DOE/ID-10679
Revision 1
September 2003

***New Pump and Treat Facility Remedial
Action Work Plan for Test Area North
Final Groundwater Remediation,
Operable Unit 1-07B***

DOCUMENT TITLE/DESCRIPTION: New Pump and Treat Facility 90 Percent Design, Draft Phase C Remedial Action Work Plan, and supporting documents for Test Area North Groundwater Remediation

Figure 1-1. Operable Unit 1-07B trichloroethene contaminant plume.

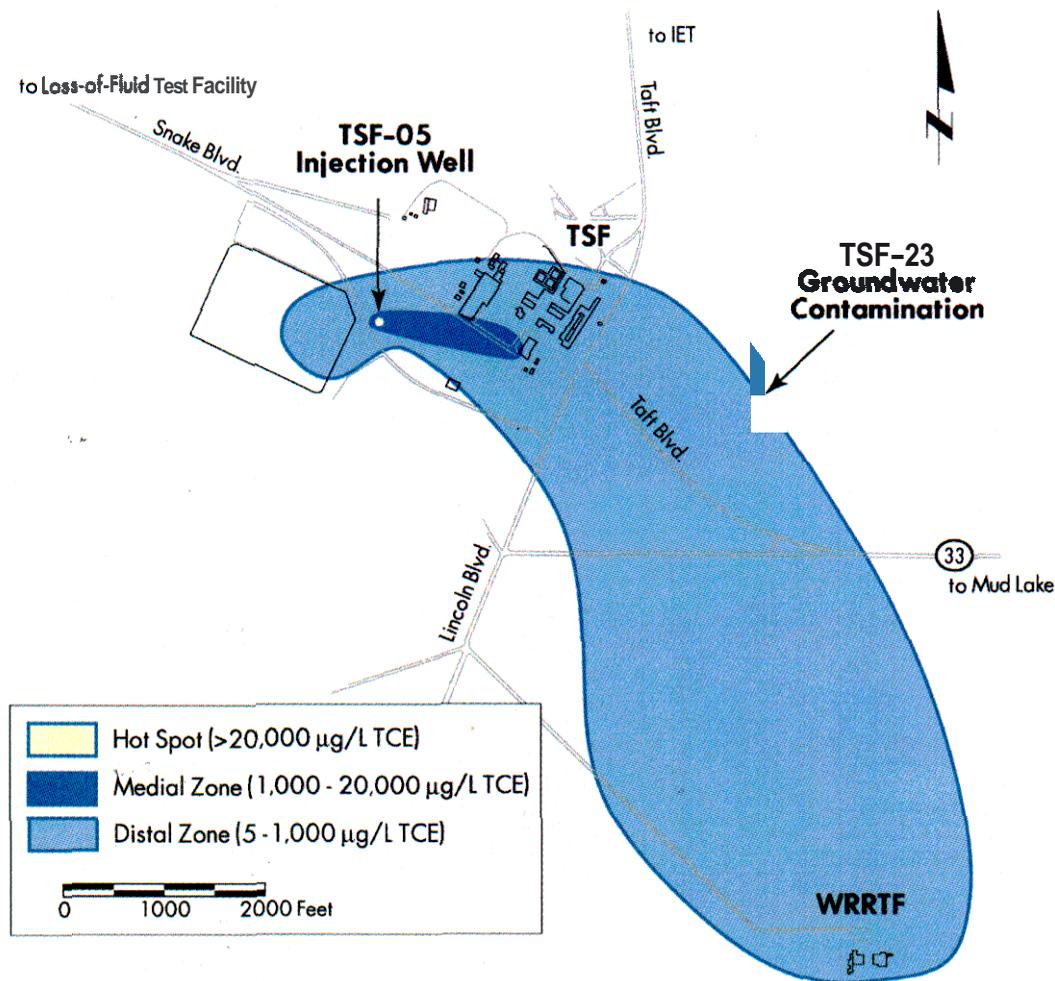
6	2-5 92.1.1.2 Table 2-3	Please include a figure depicting the locations of the monitoring wells identified in this table.	Figure 1-1 replaced to include pertinent well locations.
